EPA-430/9-77-009
Construction Grants Program
Information

VALUE ENGINEERING

CASE STUDIES AND FORMATS FOR PROPOSALS AND REPORTS

**A SUPPLEMENT TO THE VALUE ENGINEERING
WORKBOOK FOR CONSTRUCTION GRANTS PROJECTS**

**FIGURE 14. PROPOSED NEW YARD PIPING ALT.
(PLANT LAYOUT AS DESIGNED)**

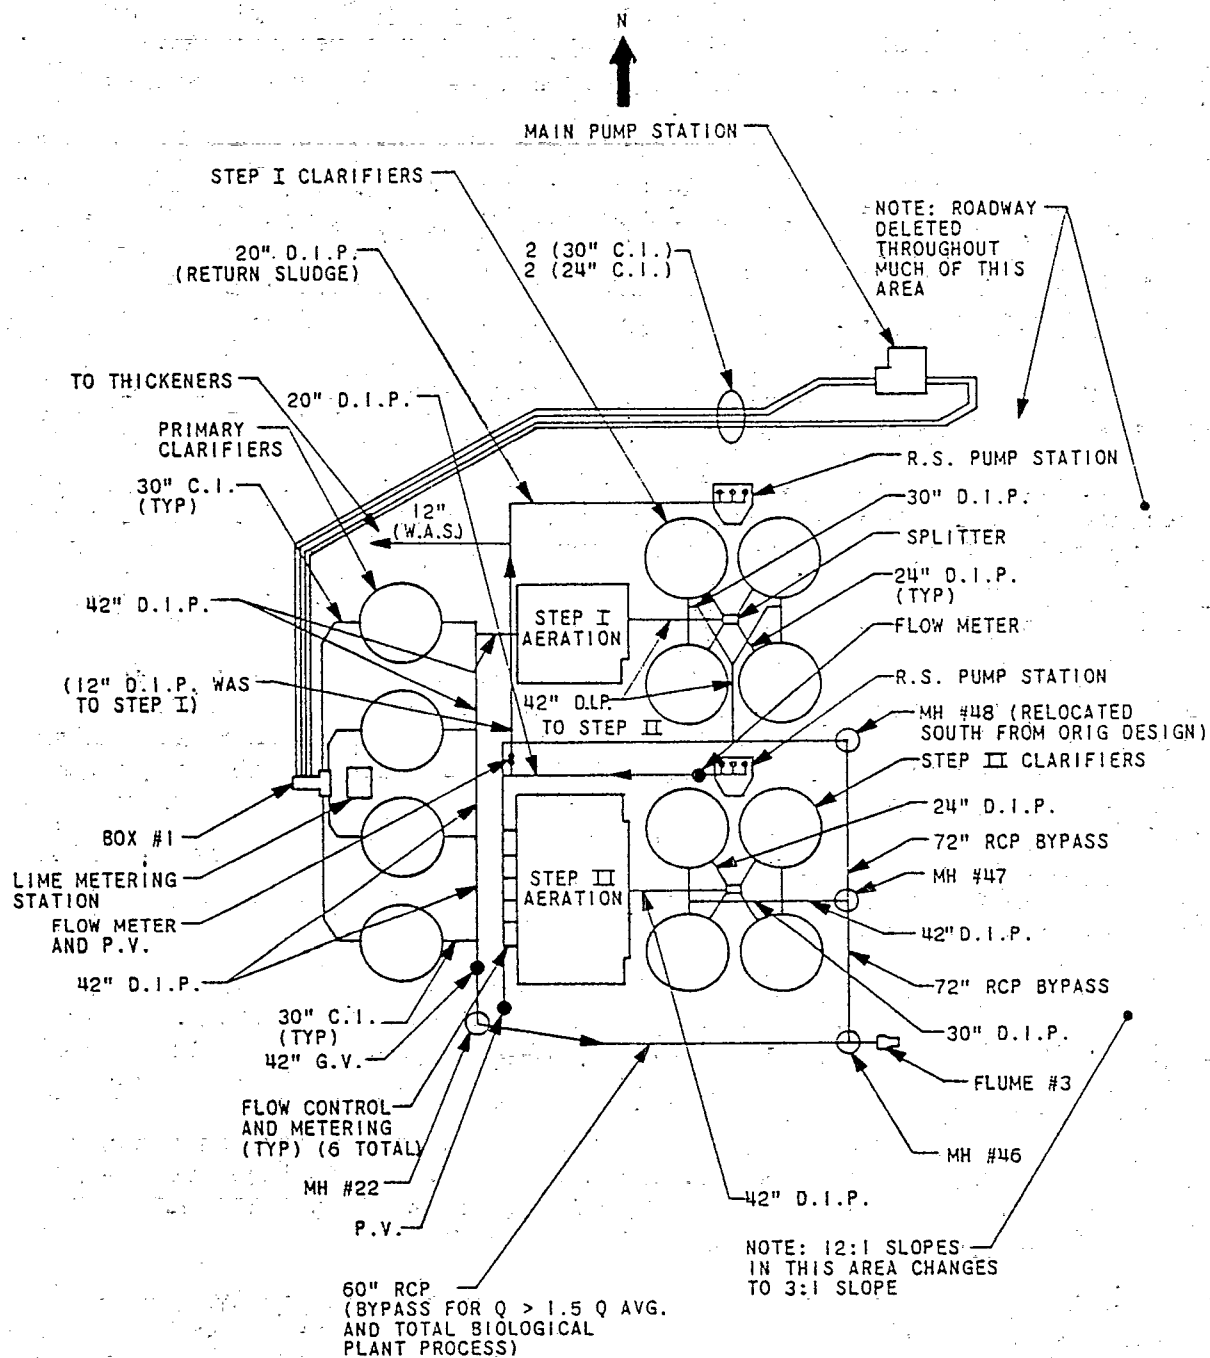
6. Figure 14. Several changes related to plant layout were proposed:

SITE PLAN AFTER WORKSHOP 1

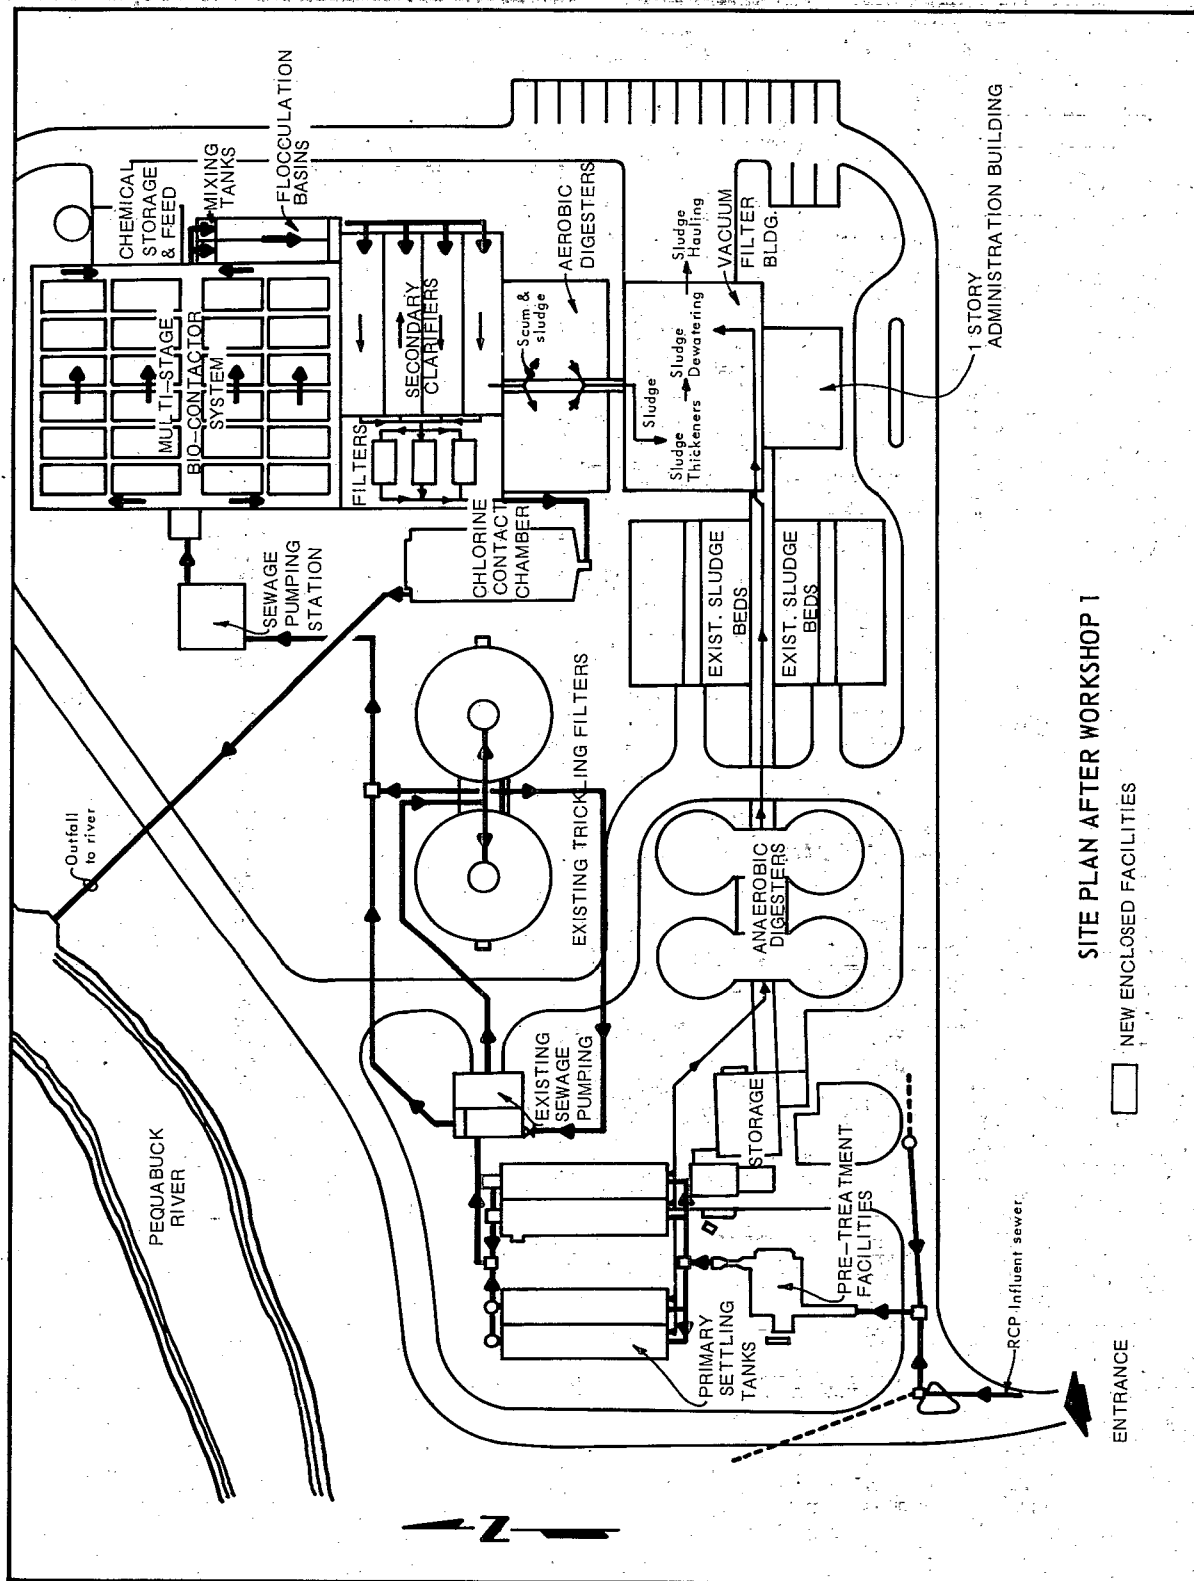
Workshop I - Site: The team proposed the consolidation of various new structures into one new structure as shown in Figure 28 and modifications of the perimeter flood control berm. This reduced the amounts of site grading and excavations as well as the fencing, piping, groundcover, drainage, rip rap and paving. The final layout proposed for the site was the work of all teams. Other items in the proposal included changing the grass covering most of the site to a natural ground cover having a higher initial cost but lower maintenance and life cycle costs and reducing the amount of site illumination from the pre-VE plan of lighting the entire site with pole mounted flood lights to using a minimum amount of building-mounted flood lights.

SCHEMATIC FLOW DIAGRAM AFTER WORKSHOP 1

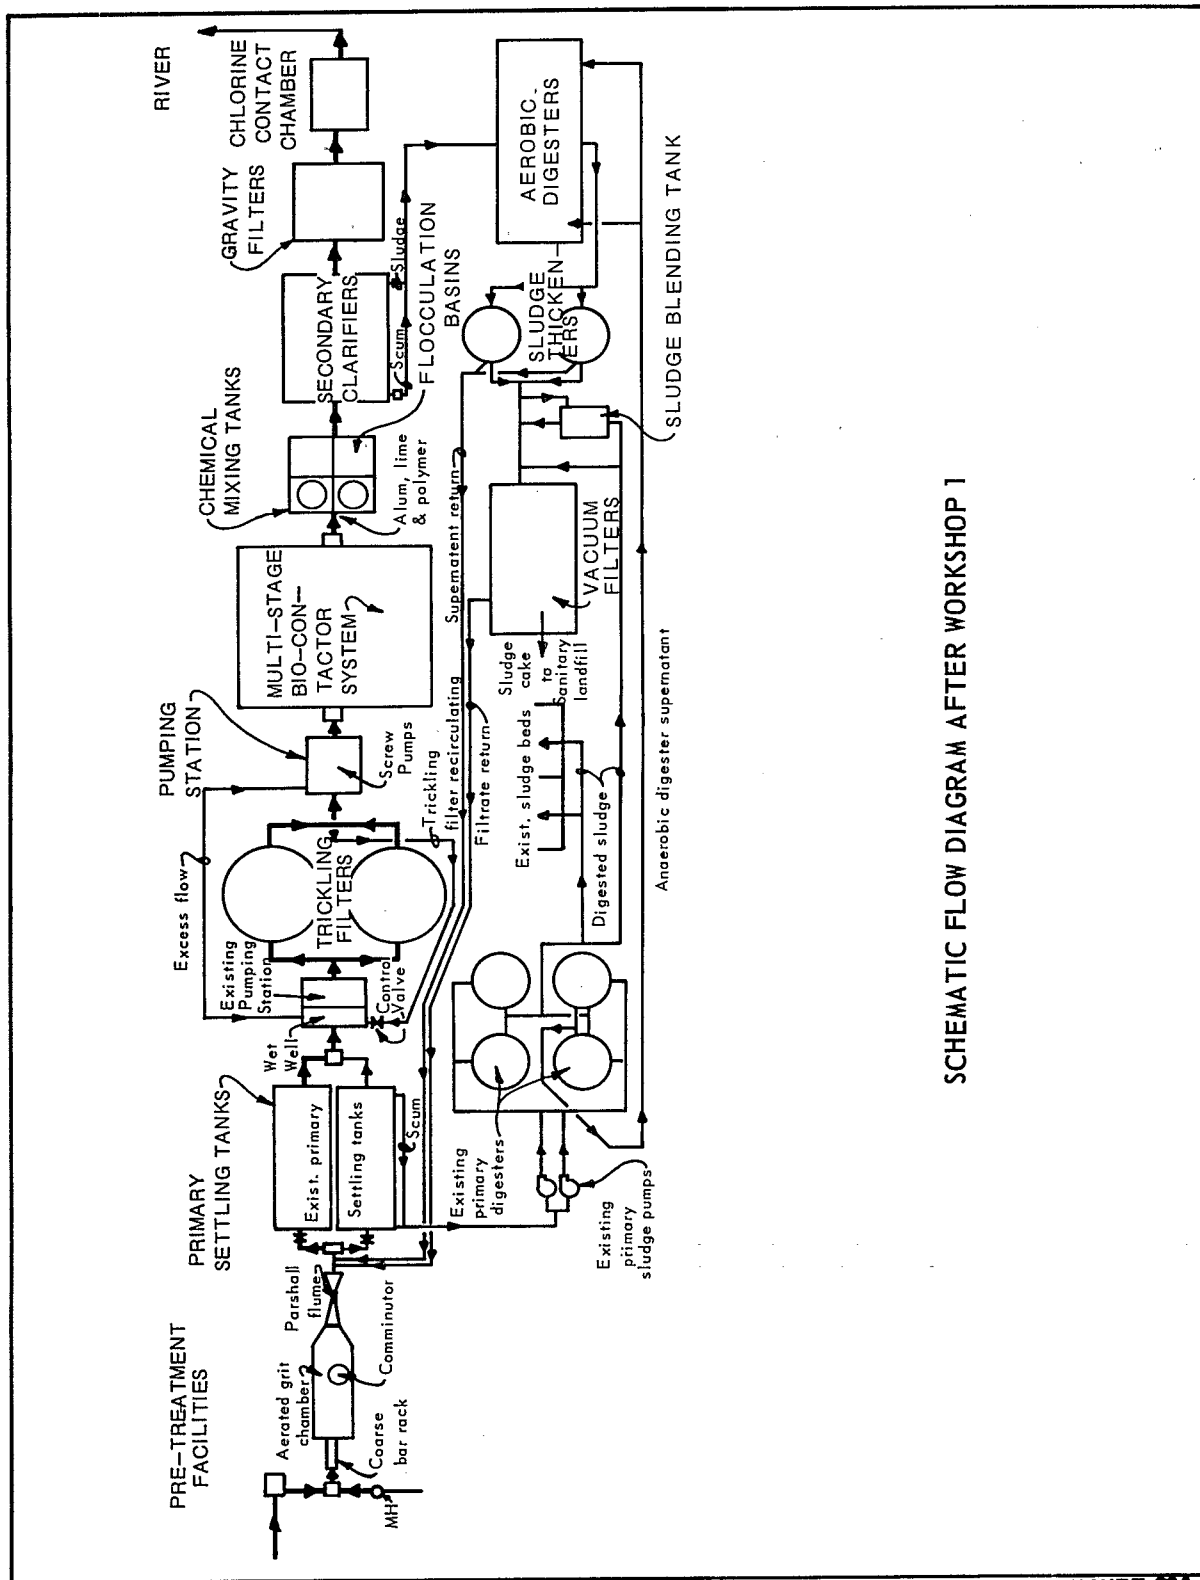
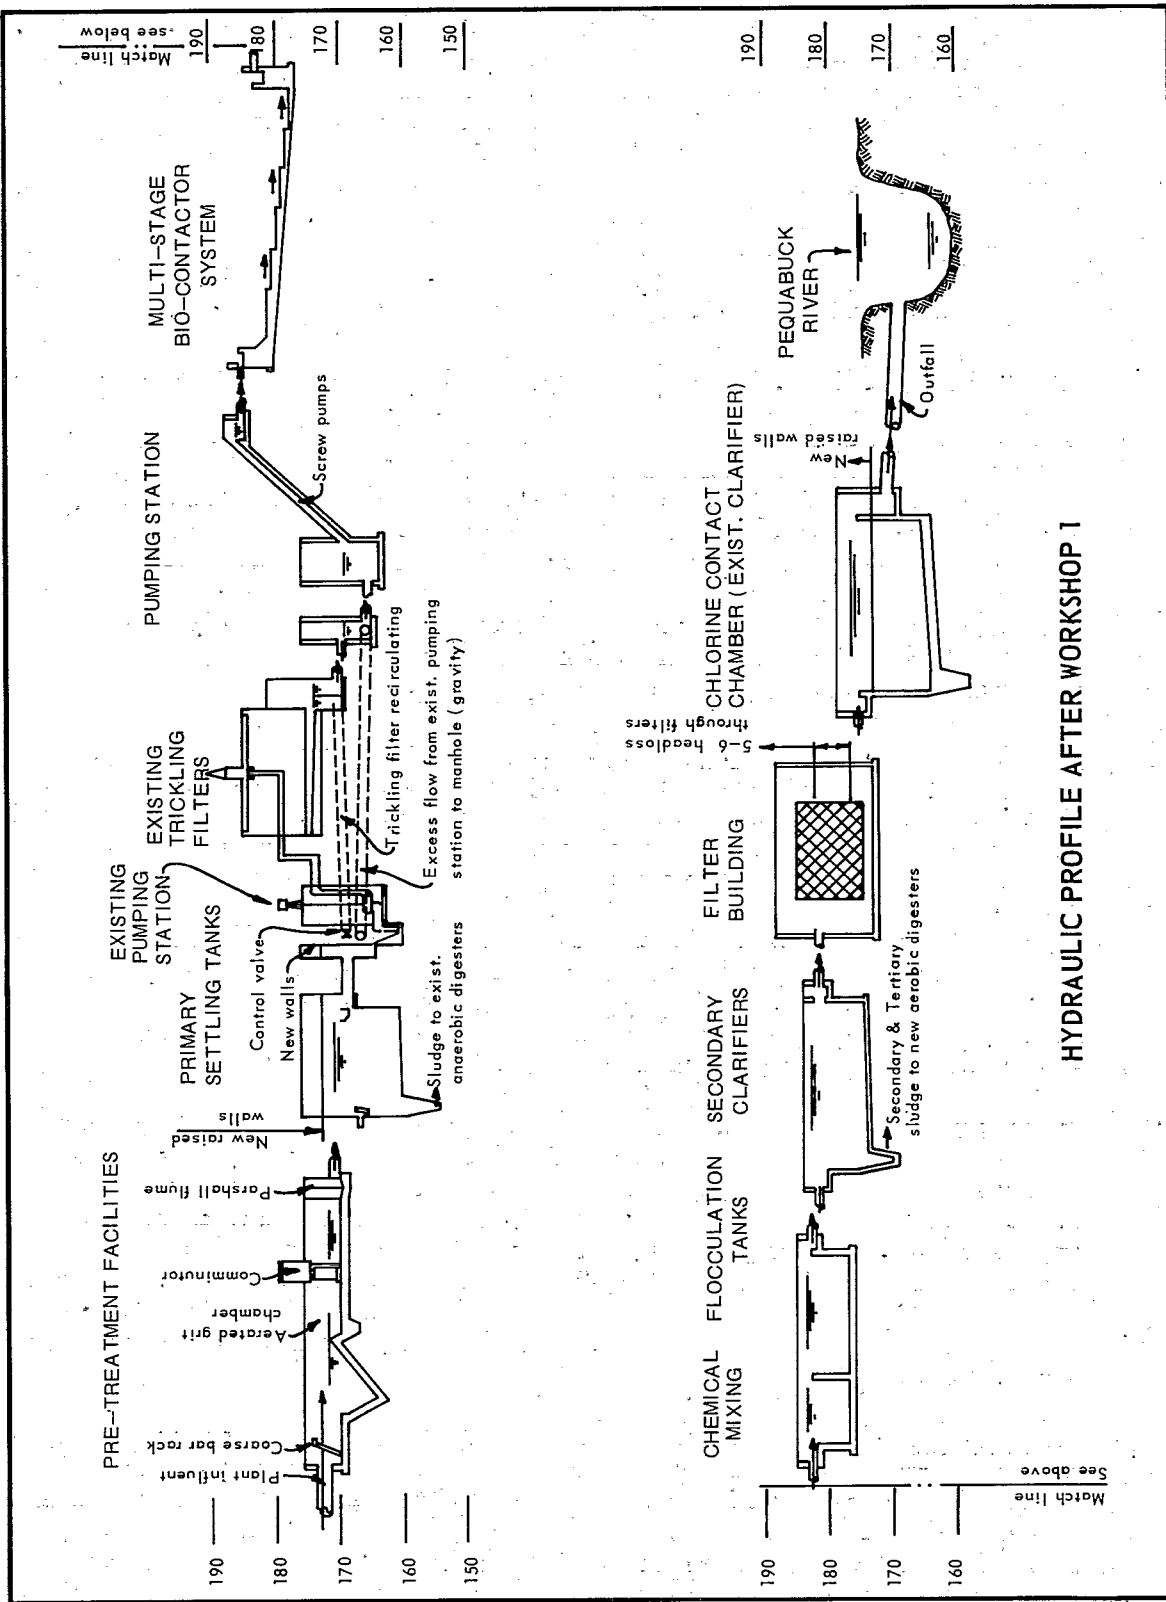
Workshop I - Process: This team developed new process flow sheet and hydraulic profile (Figure 29) on which the team could base many of their proposals. This new flow sheet retained the existing trickling

filters as roughing filters rather than converting them to equalization basins. The use of roughing filters reduced the organic loading on the biodisc process and allowed the deletion of four of the 28 biodiscs. Other proposals by the team included (1) changing a new low lift pump from the multi-speed centrifugal type to screw type (2) changing flocculation equipment from biodiscs to conventional flocculators (3) using gravity filters in place of pressure filters and thereby eliminate three pumps and a standby generator (4) converting existing (hydraulically inadequate) secondary clarifier to a chlorine contact basin and (5) eliminate the septic waste holding tank.

FIGURE 30
BIODISC WALLS

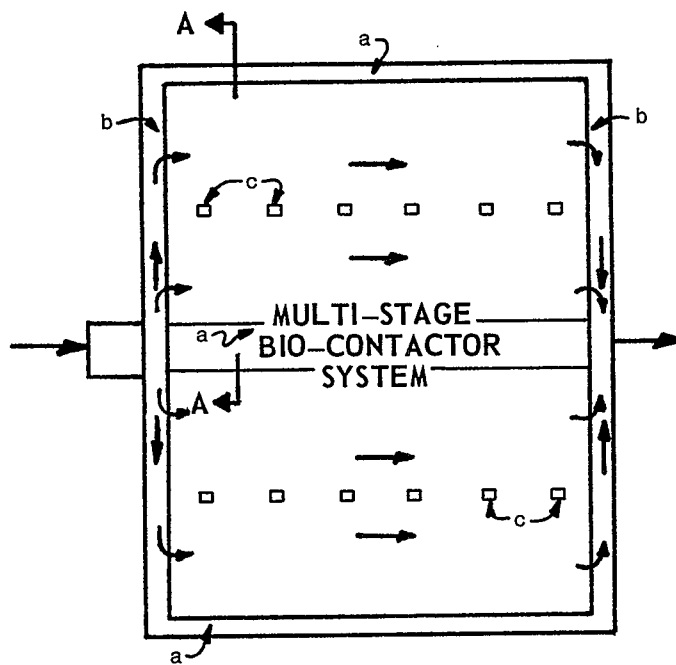
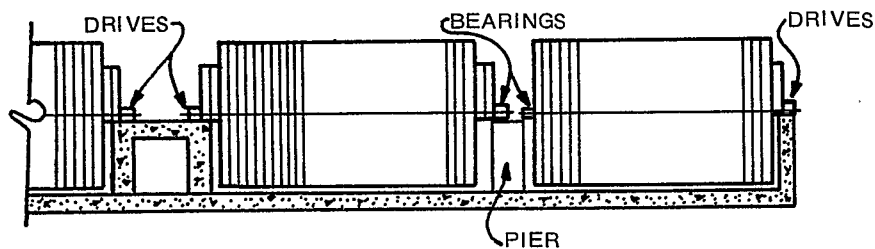
Workshop II - Buildings: In the interim between workshops, it appears that the concrete structure over the biodiscs (replaced with plastic covers during the first workshop) was reincorporated into the design as was concrete framing for the administration building. A proposal of the second workshop replaced the concrete framing with steel framing and reduced the heights of both structures. Another proposal

28 BIODISCS (AS SHOWN)	24 BIODISCS (VE PROPOSAL)
TOTAL LENGTH OF WALLS	1160 lf	1040 lf
TOTAL LENGTH OF CHANNELS	410 lf	380 lf
TOTAL LENGTH OF ACCESS WALKS	200 lf	170 lf

SAVINGS OVER ORIGINAL WAY
TOTAL LENGTH OF WALLS	600 lf	440 lf
TOTAL LENGTH OF CHANNELS	400 lf	140 lf
TOTAL LENGTH OF ACCESS WALKS	200 lf	30 lf

ESTIMATED SAVINGS DUE TO NEW DISC LAYOUT: \$75,000

WORKSHOP 2 - SITE TEAM
RECOMMENDATIONS

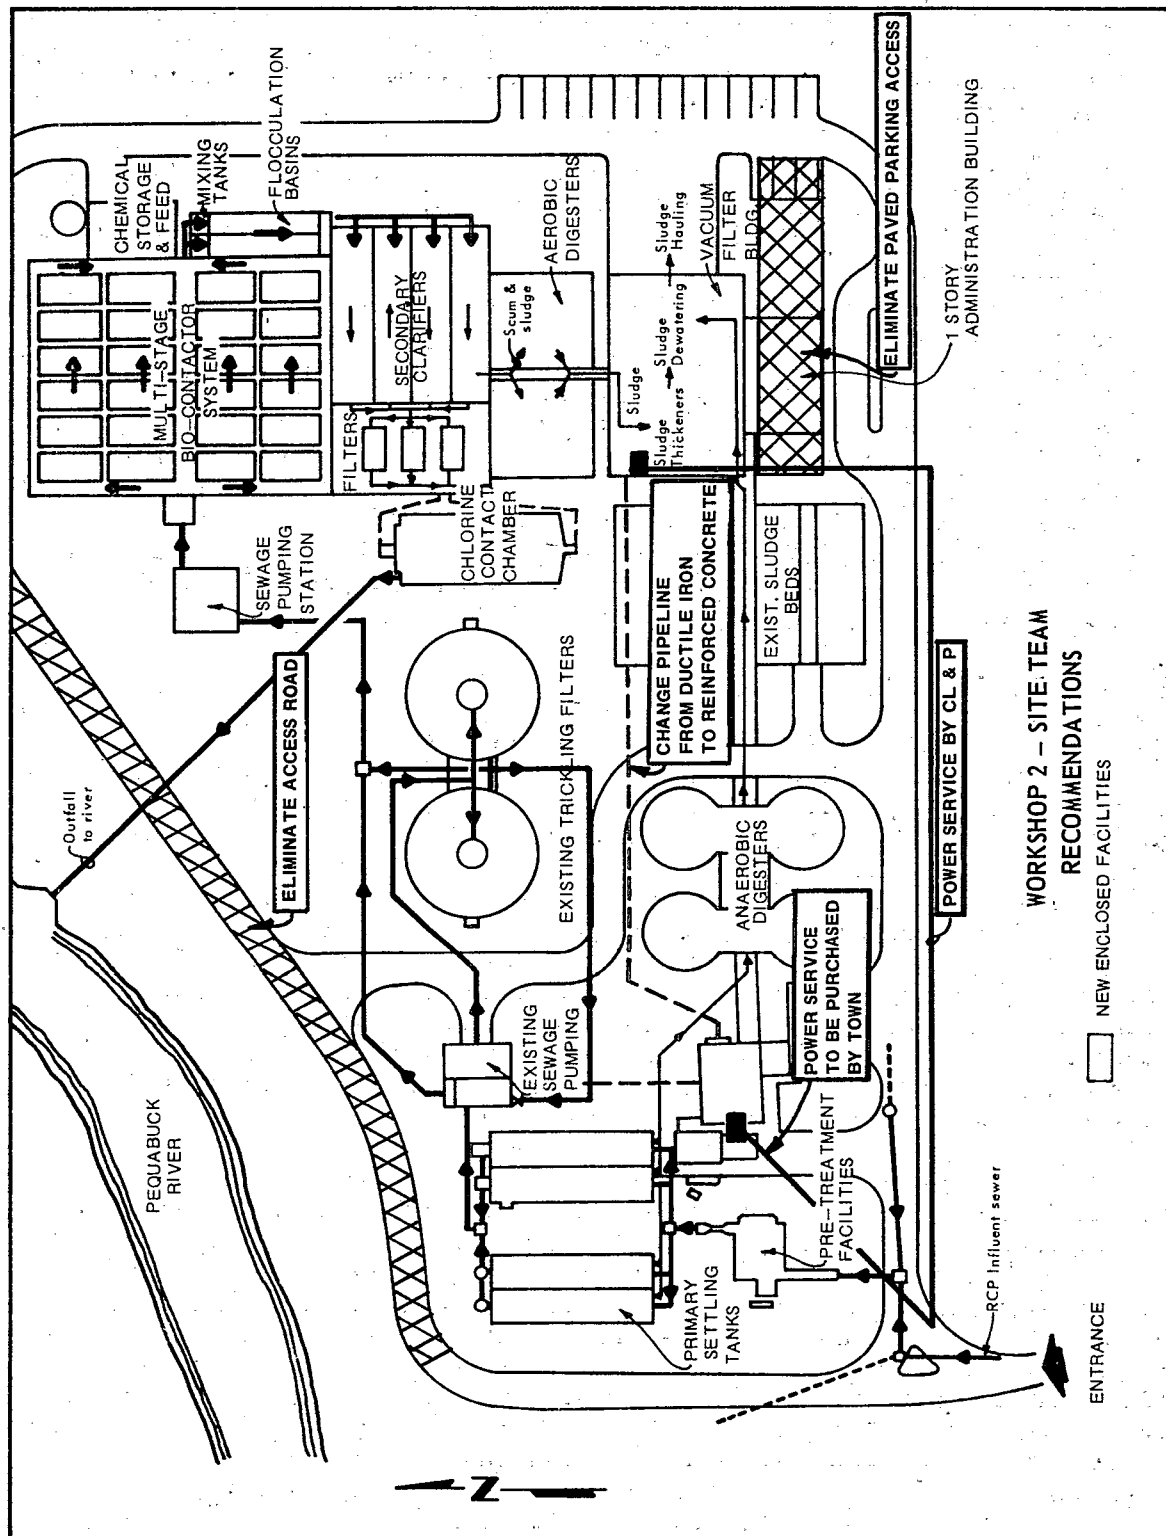
Workshop II - Site: Several items proposed by this team are shown in Figure 32. These include elimination of some access roads, changing material of a 24 inch pipeline from ductile iron to reinforced concrete, revision of the electrical distribution system to provide separate services to the new treatment building and to the existing control building. Other proposals involved changes to and reductions in landscaping, retention of an existing garage scheduled for demolition (the garage will be used by the Town for purposes not associated with sewage treatment).

FIGURE 34
CONTRACT 10, ITEM 5

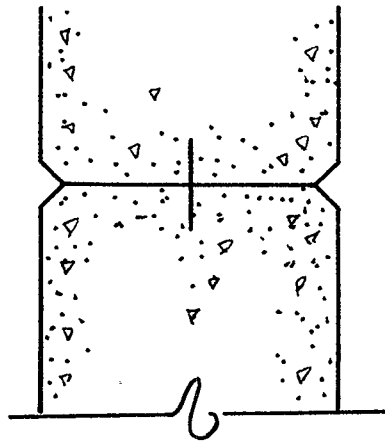
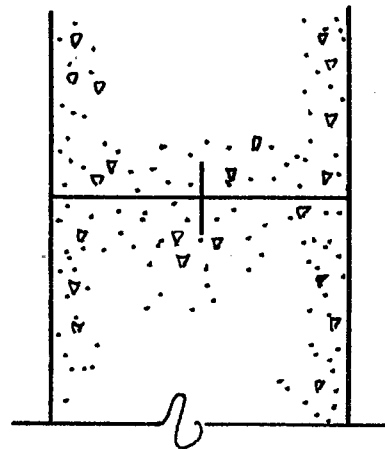
<u>Accepted Suggestions</u>	<u>Savings</u>
5. Eliminate Chamfer at Construction Joints. Leave Edges Square (See Figure 34)	\$ 19,440
6. Use Aluminum Extrusion In Lieu of Built Up Sheet Parts for Stop Plank (See Figure 35)	\$ 36,356
